City of Bixby Planning Commission Meeting Agenda

Monday, August 21, 2023

To: City of Bixby, Planning Commission
From: O.C. Walker, Director of Development Services
Date: Monday, August 21, 2023
Name: South County Industrial Park
RE: Planned Unit Development PUD-12, Major Amendment C
Location: One-half (1/2) mile North of 151st Street and West of Kimberly Clark Place, approximately 70 acres.
STR: Section 16, Township 17N, Range 13E
Applicant: Bell Land Use, LLC – Robert Bell

To: City of Bixby Planning Commission
From: O.C. Walker, Development Services Director / City Planner
Date: Monday, August 21, 2023
RE: Tangelo Orthodontics
Location: 12265 South Memorial Drive, Bixby, Oklahoma
STR: Section 1, Township 17N, Range 13E
Applicant: Brad McMains

Figure 1: City of Bixby Zoning Map

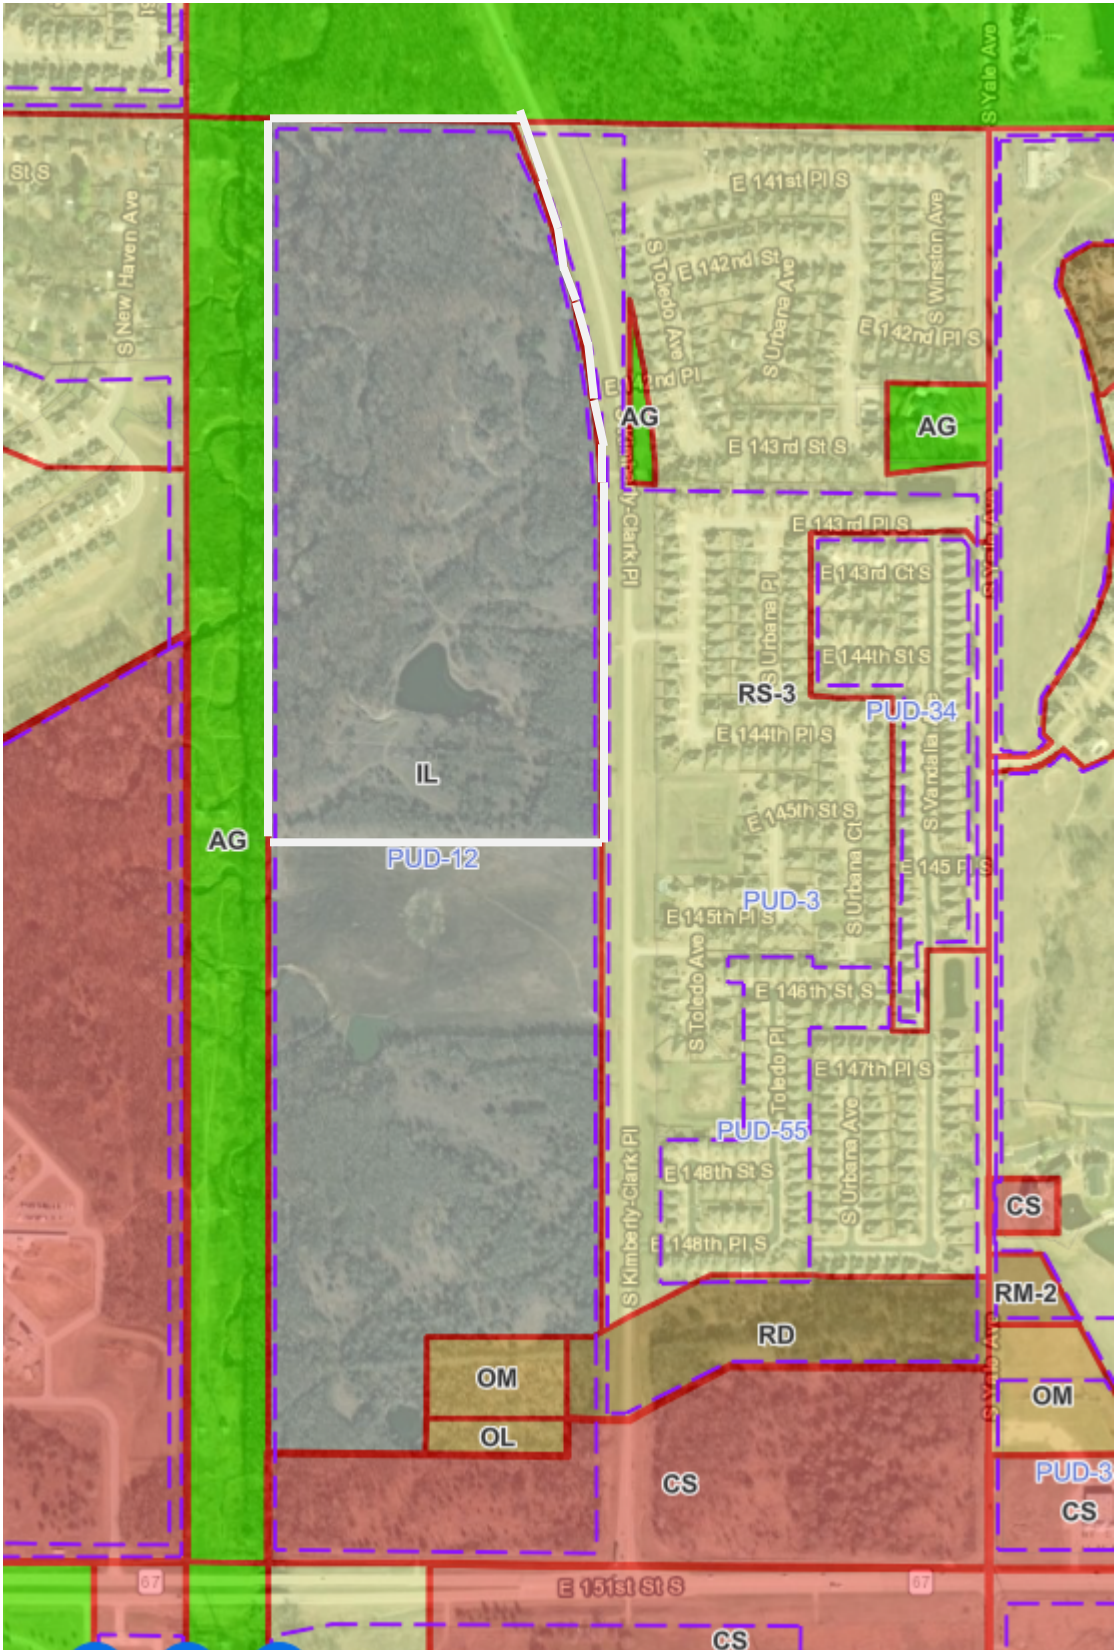
1. Shall comply with Corridor Appearance District requirements
2. Lot Splits approval process will be authorized by the Planning Staff
3. Shall comply with the PUD 12, Major Amendment C for the following:
 - a. Screening
 - b. Signage
 - c. Parking
 - d. Drainage and Utility
 - e. Existing Zoning and Comprehensive Plan
 - f. Site Plan Review

1. Staff supports the Planning Commission recommendation for approval of the requested Planned Unit Development (PUD) Amendment C, with Planning and Engineering comments implemented to the Plat before moving to Council.

B5 Architectural Site Plan
NOT TO SCALE

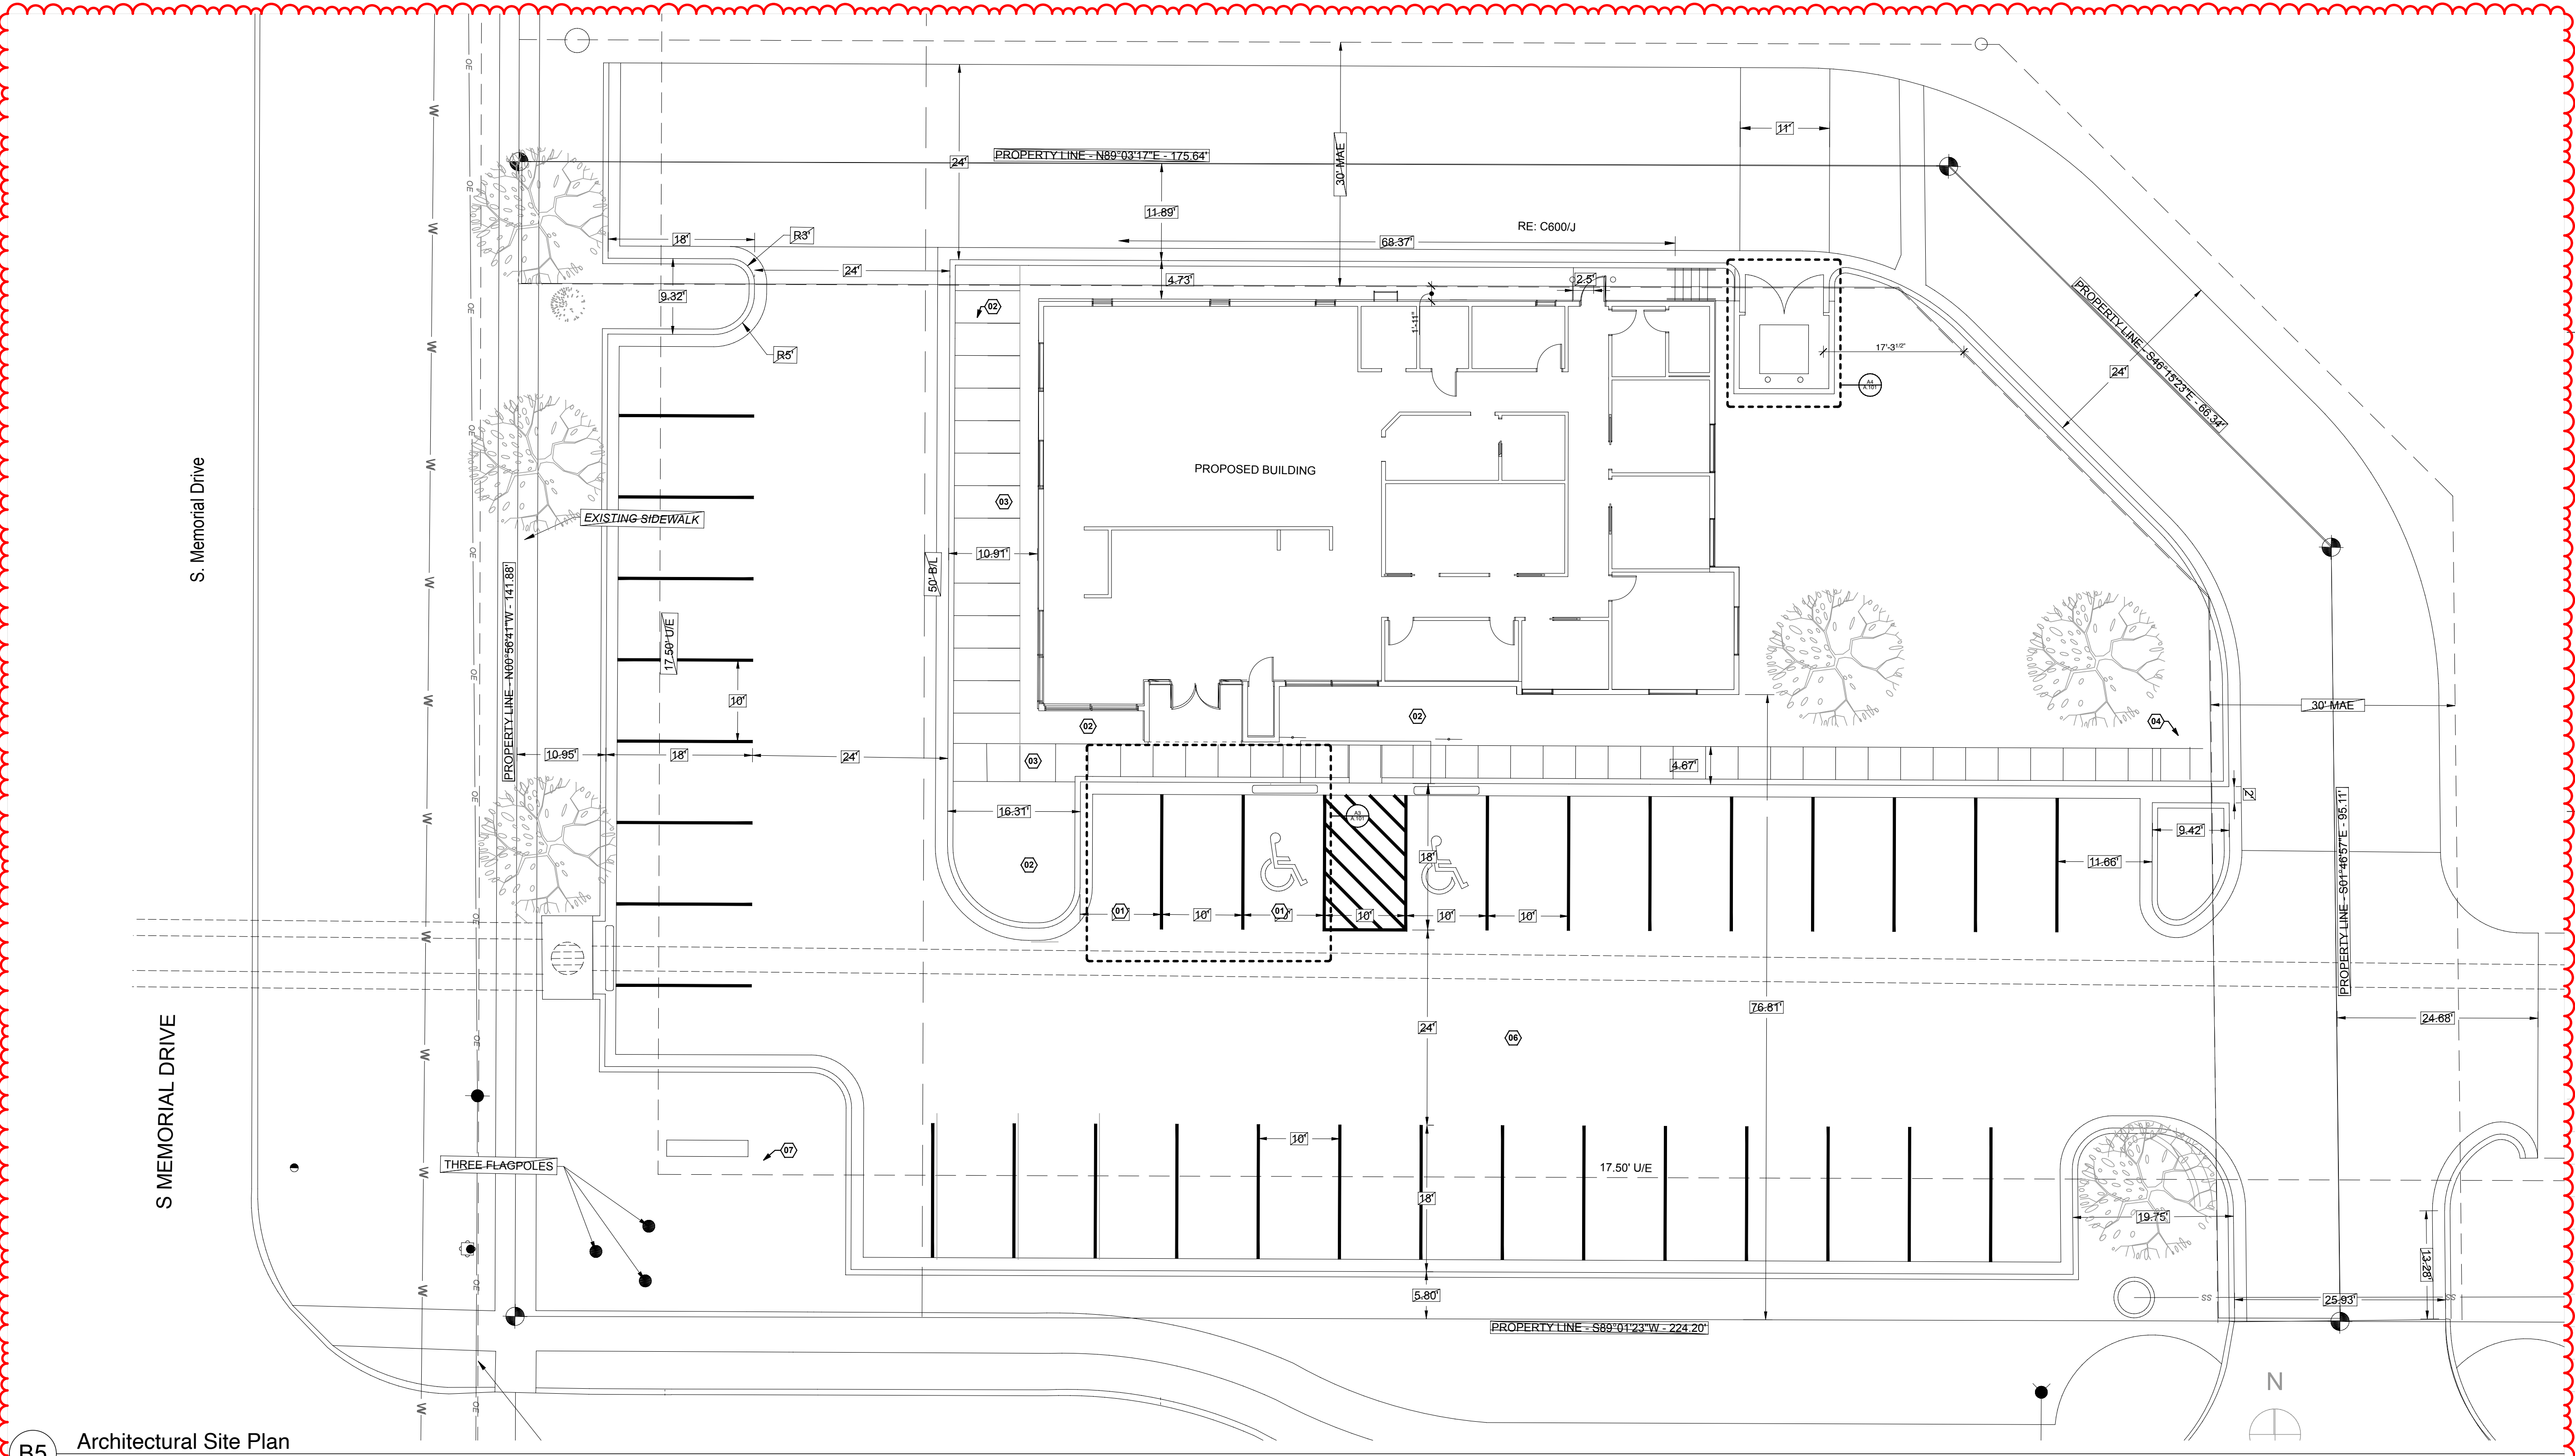
- All landscaping shall be in accordance with the City of Bixby standards
- All lighting shall be in accordance with the City of Bixby standards
- Remove the access point to the west
- Provide building elevation material
- Dumpster shall be enclosed with 95% opacity material
- Egress point to the north of the site shall be a right turn only
